2.1 Distribution of the Draft EIS/EIR

2.2 Comments on the Draft EIS/EIR

¹ See Attachment 1: Letter from Douglas Hansen, Director of Strategic Planning, YTI, to Mr. Chris Cannon, Environmental Management Division, Port of Los Angeles. Dated September 18, 2014. Re: Responses to Comments on Port of Los Angeles Draft EIR/EIS Report- Berths 212-224 Container Terminal Improvement Project

Figure R.1: Mitigated Proposed Project State 1-hr NO₂: Construction

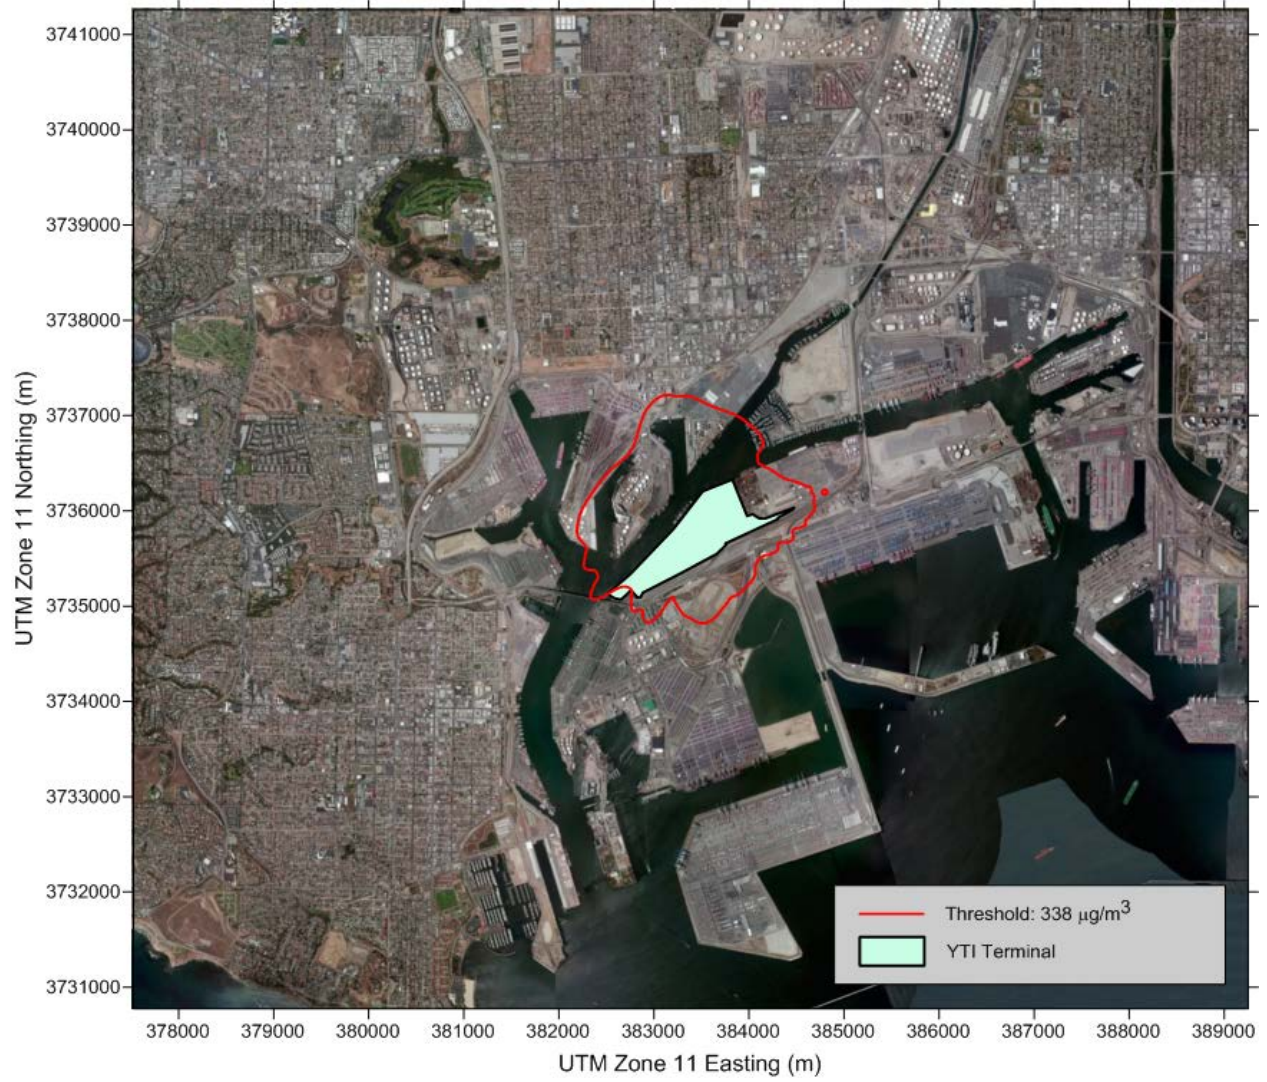
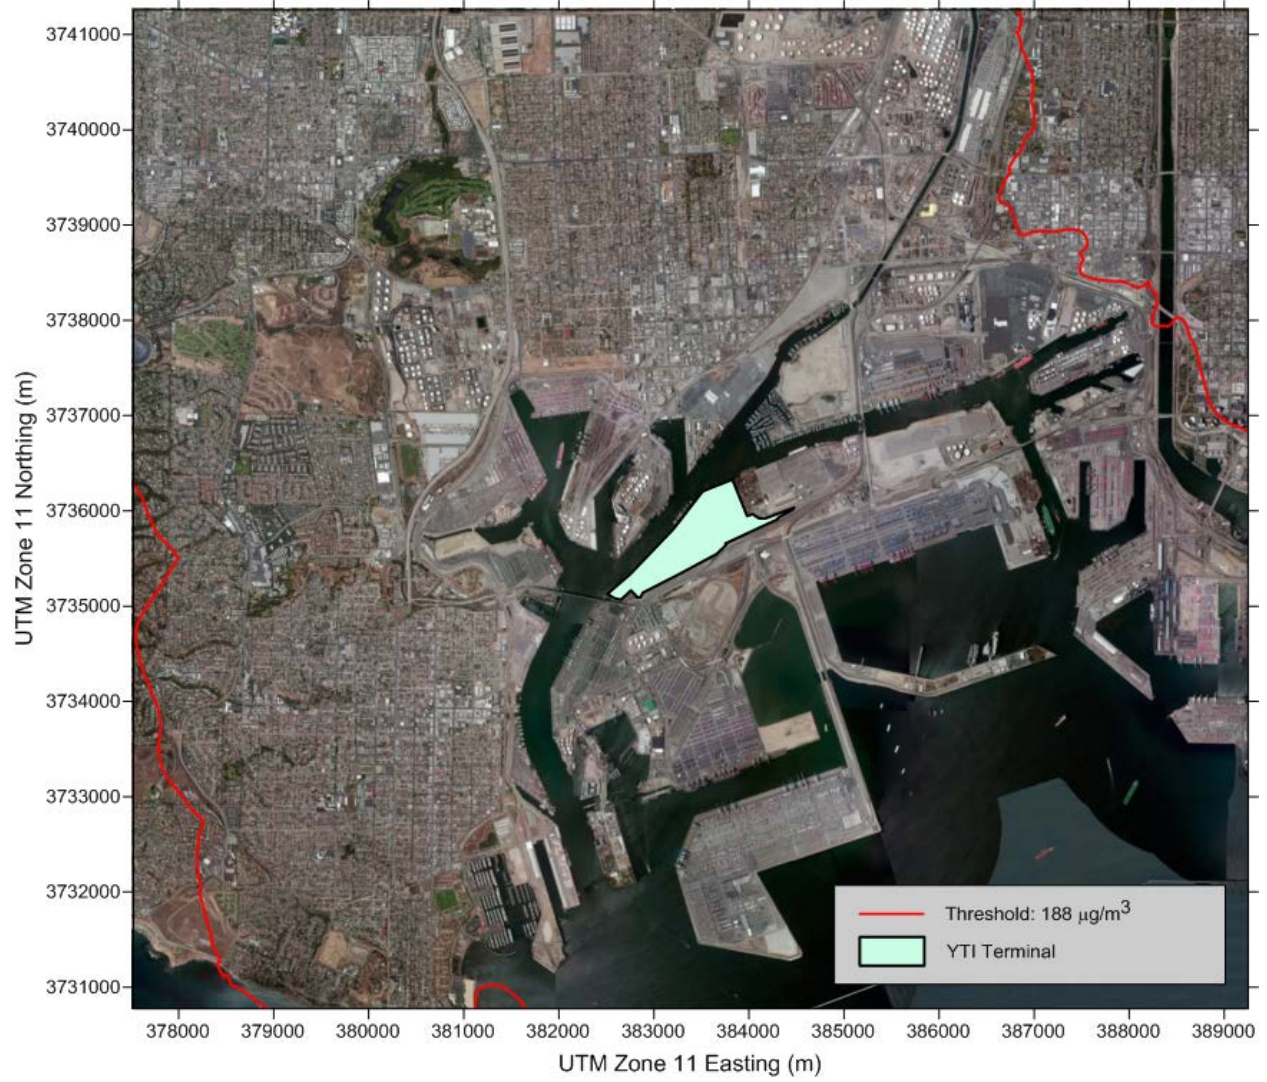
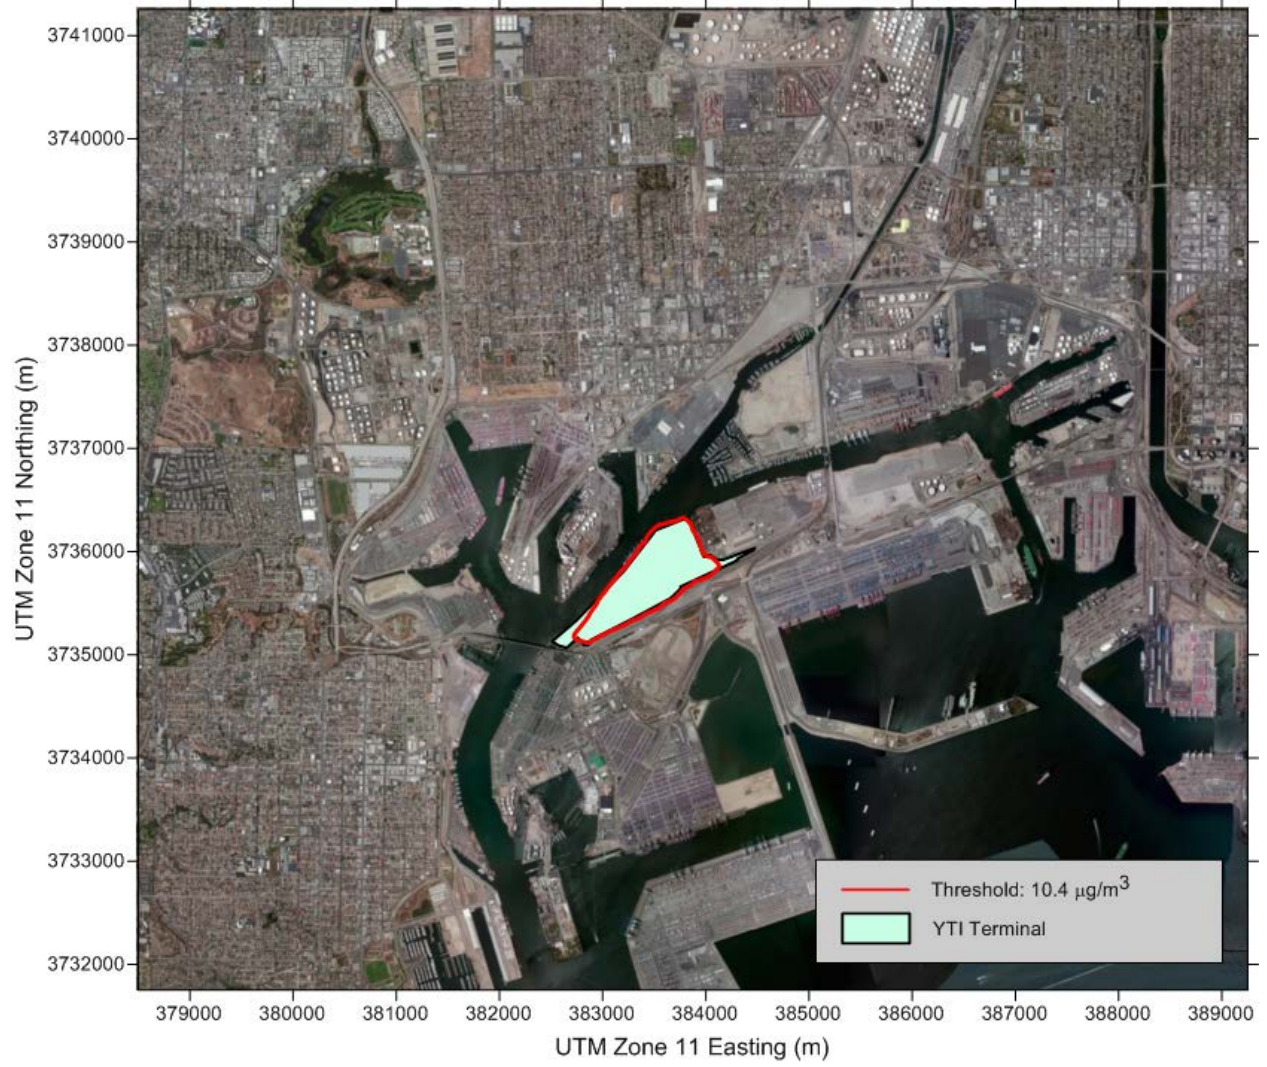
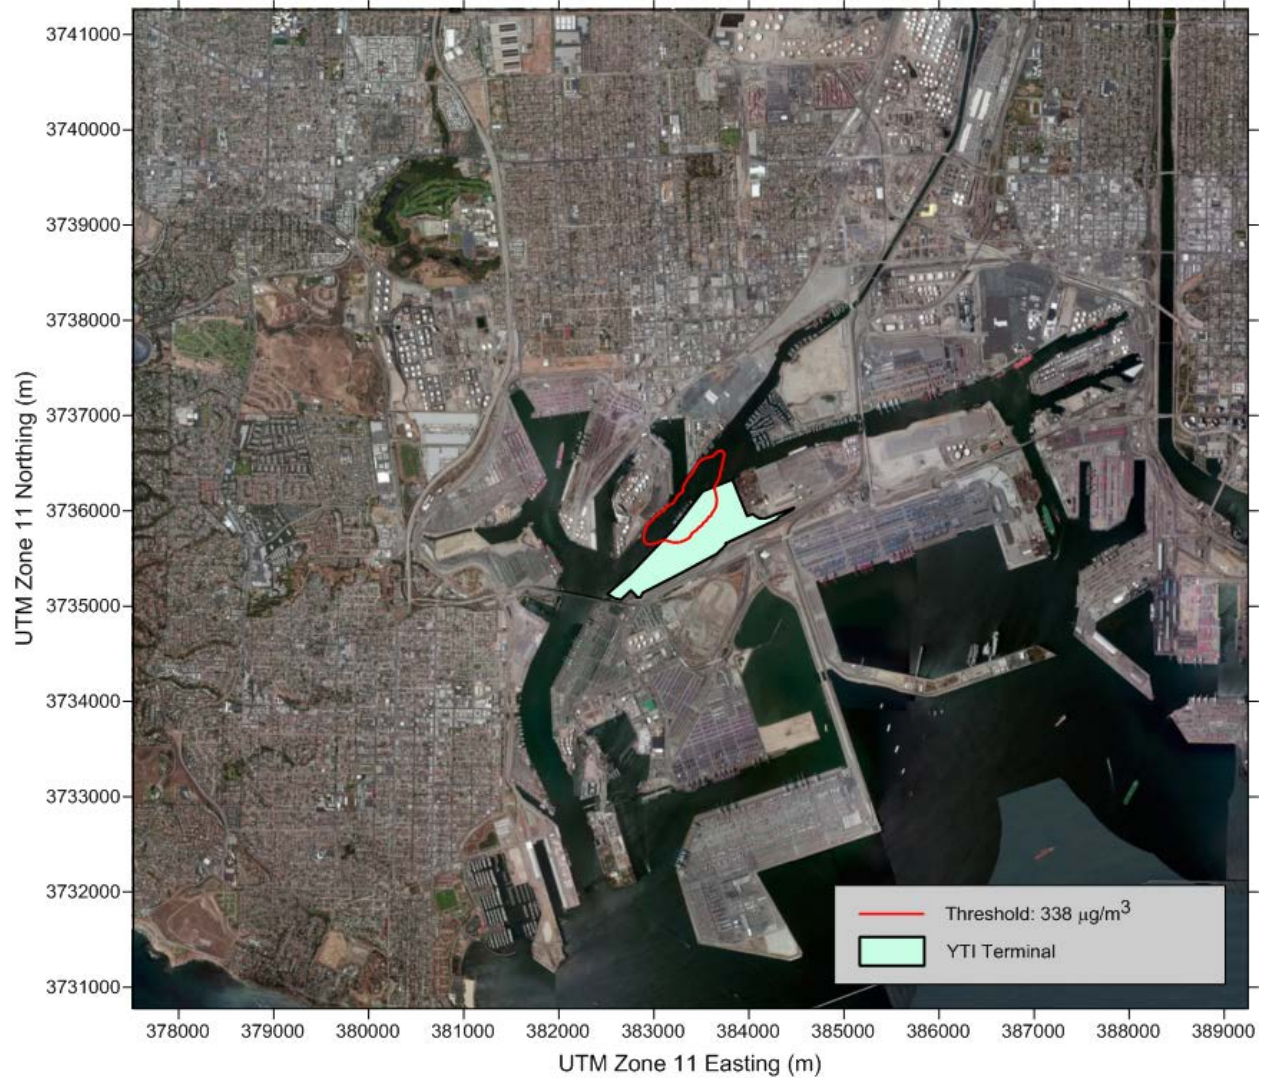
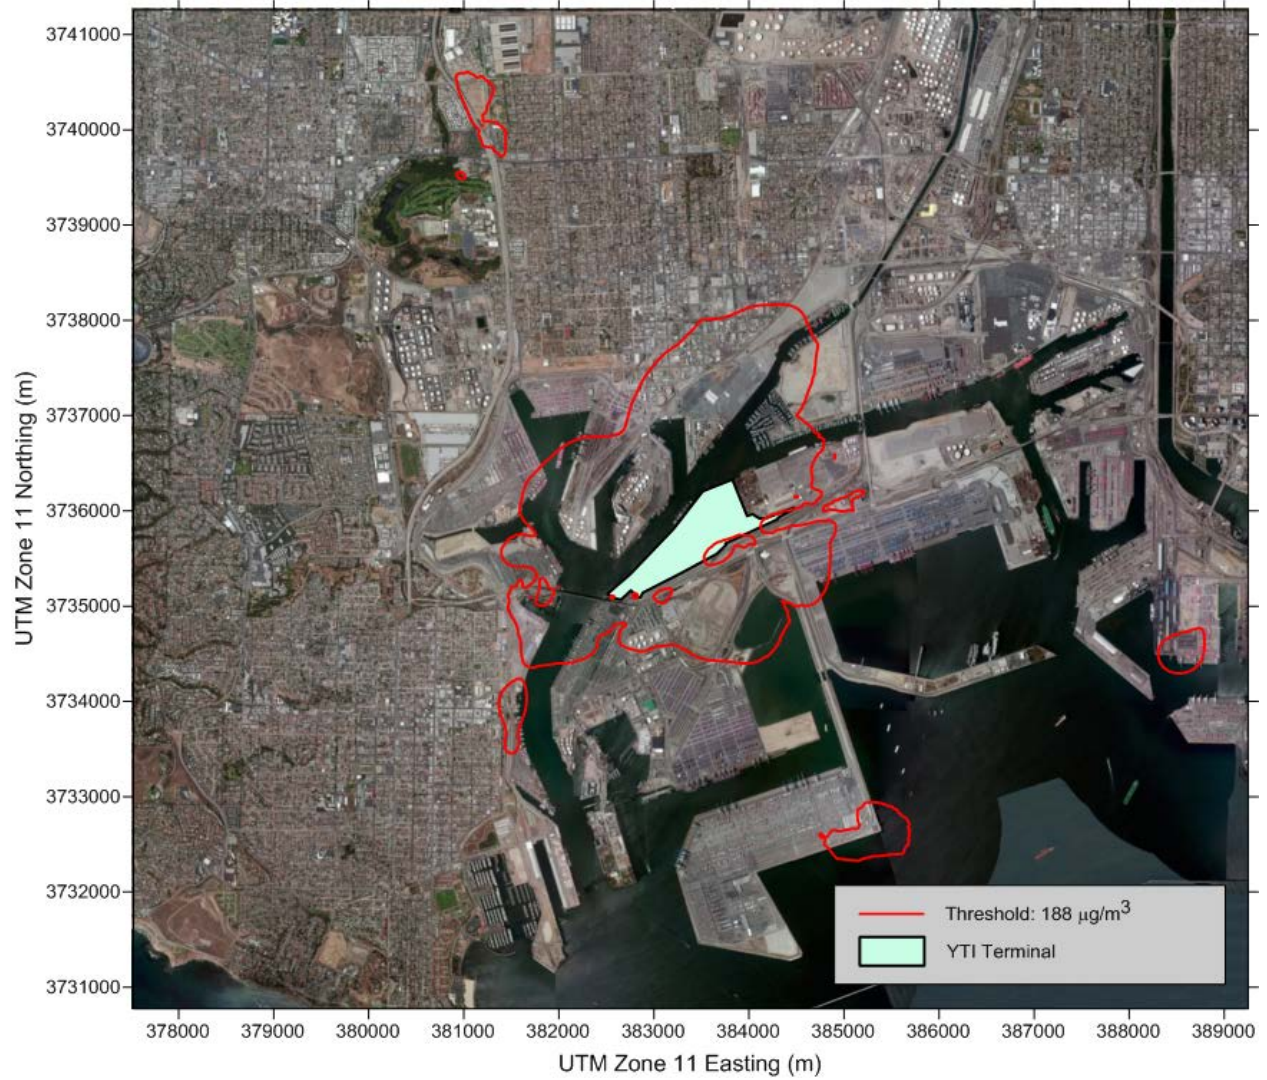
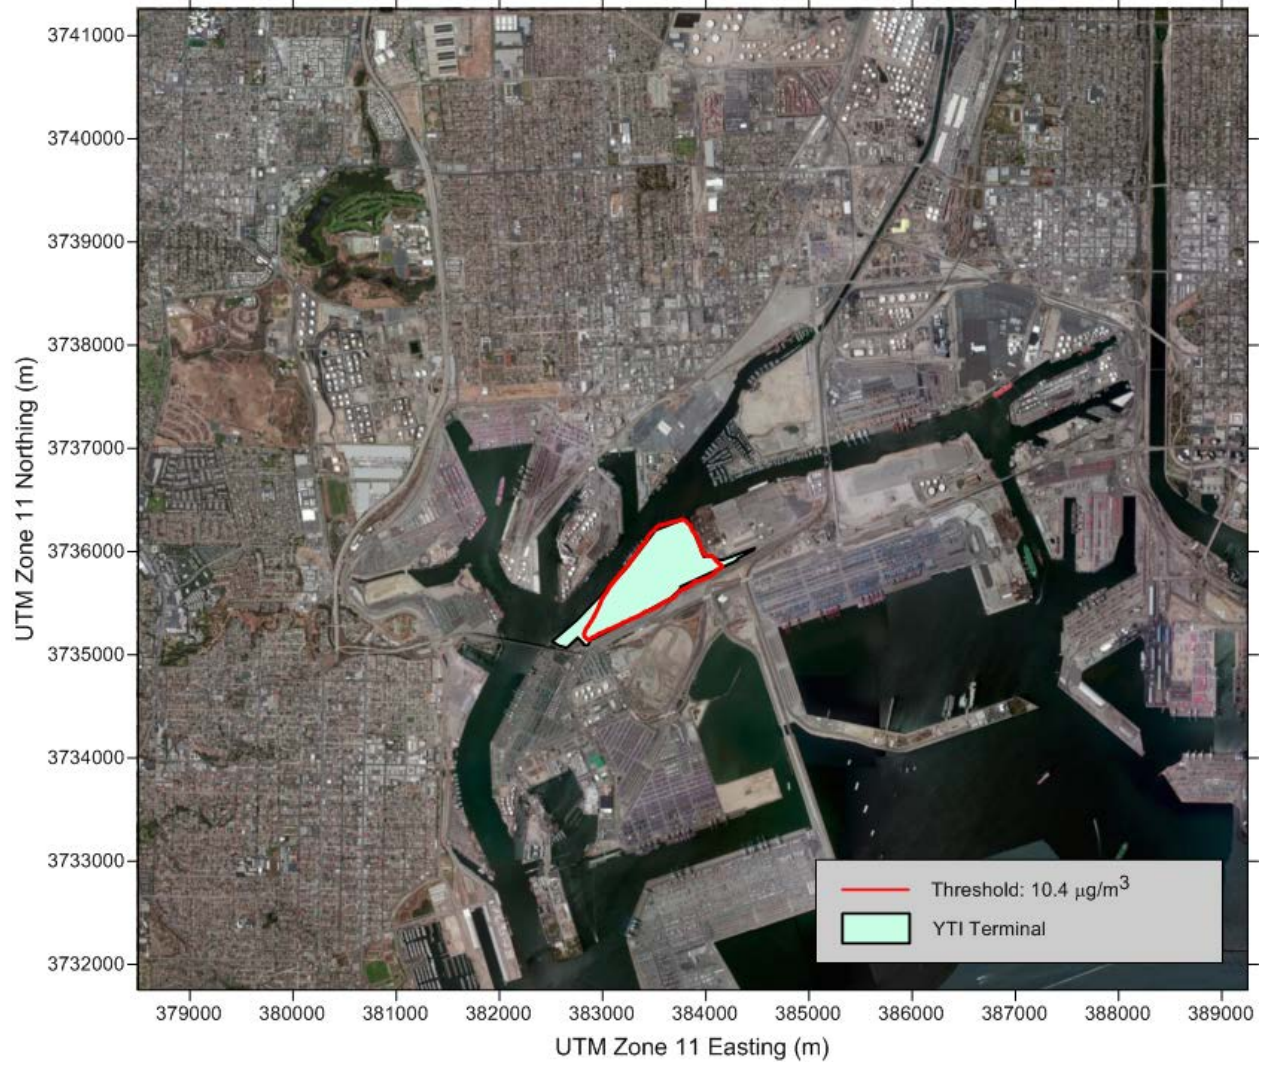
The EIR and appendices contain tables and text describing the dispersion modeling of criteria pollutants, however no maps are provided showing the extent of those impacts. The only maps provided (e.g., Figure 3-16 in Appendix B2) only show the points of maximum impact. Maps that show contours of all areas affected
